DATE: 12.19.2018

■ **MCDONALD'S REMODEL [TRC Plan Review]**

↻ Initial Review Note ↻

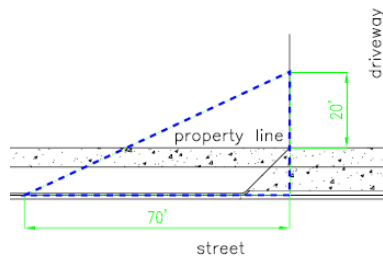
- Revise all sheets to accurately illustrate the existing conditions on and surrounding this parcel. Show all adjacent traffic signs, lane configurations, traffic control devices and pavement markings for the intersection of Military Cutoff Rd/Eastwood Rd, Military Cutoff Rd/Commonwealth Dr on the site inventory plan. Please refer to the Technical Standards and Specifications Manual (link is below) Ch. VII C.1.a.2. for specific information and distance requirements. Contact Traffic Engineering at 341-7888 if you need assistance locating these elements.
<https://www.wilmingtonnc.gov/home/showdocument?id=1910>
